E. Project 2015-10 Single Points of Failure TPL-001 12

Exhibit A Proposed Reliability Standard TPL-001-5

Figure 5-12 — Station DC Supply and Monitoring

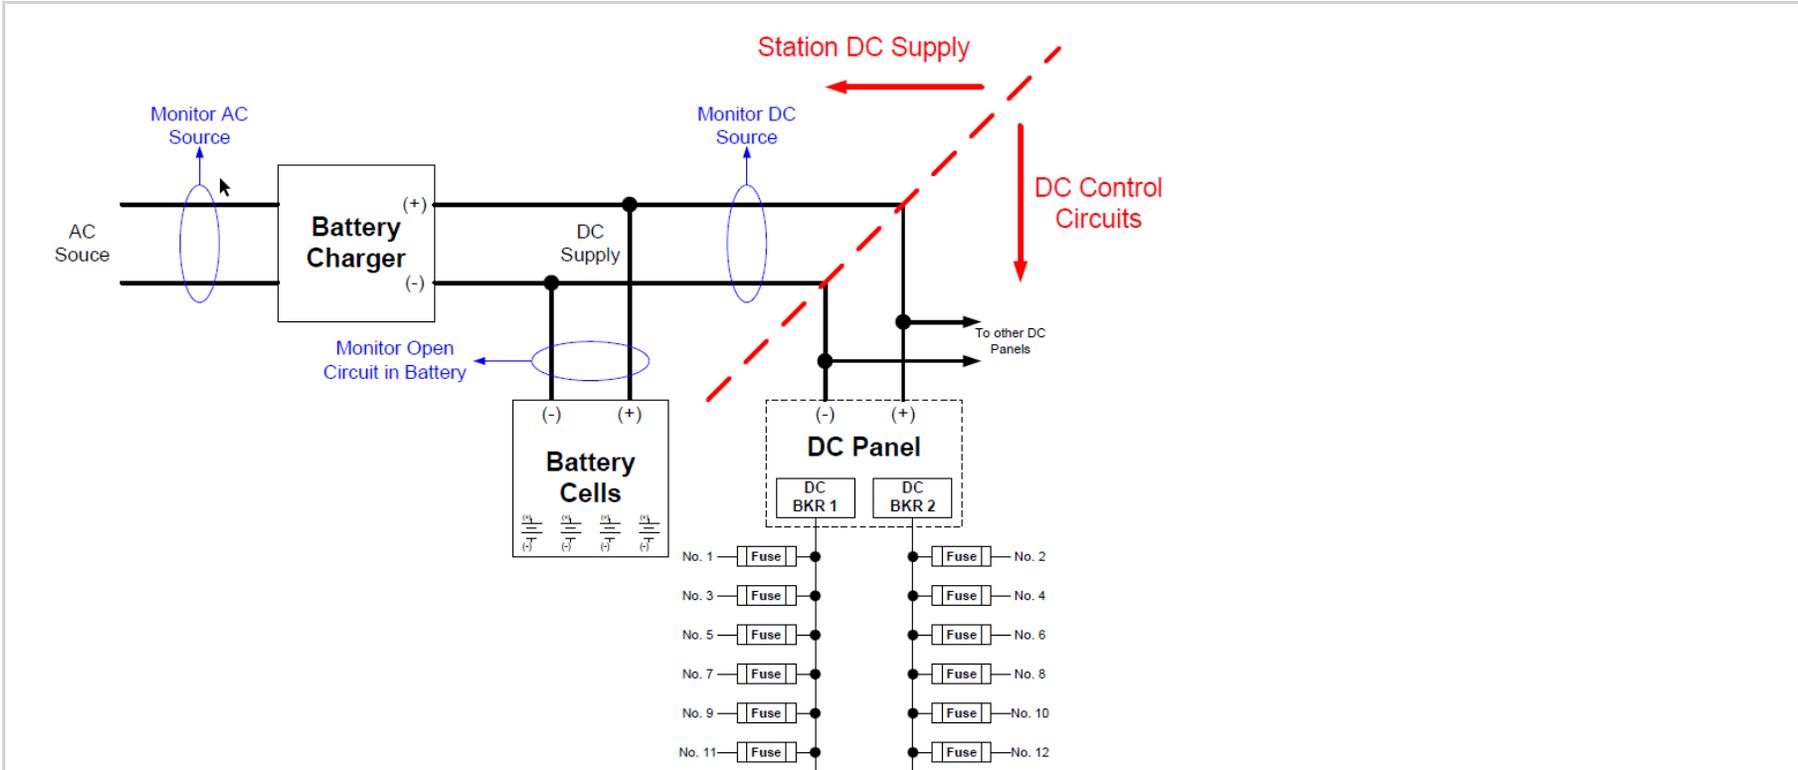
Document Name	
Comment	
<p>Hydro One still has concerns with the following points regarding Footnote 13:</p> <ol style="list-style-type: none"> 1) 13c – The term “open circuit” is not clear. Please provide clarification of the term and an example of how it is typically monitored in the supplementary material for better understanding. 2) 13d – We recommend that a single trip coil that is “monitored and reported at a Control Center” be treated the same way that communication systems (Footnote 13b) and DC Supply (Footnote 13c) are treated (to meet the redundancy requirement). 	
Likes	0
Dislikes	0

Response	
<p>1) There is a NERC Technical Paper dated November 2008 titled “<i>Protection System Reliability Redundancy of Protection System Elements</i>” which explains why monitoring an “open circuit” is required. The SAMS and SPCS recommendation from Order No. 754 and Section 1600 data request aligns with most of the elements in the NERC Technical Paper. For reference Figure 5-12 is copied from this technical paper.</p>

2) Monitoring was added to footnote 13d.
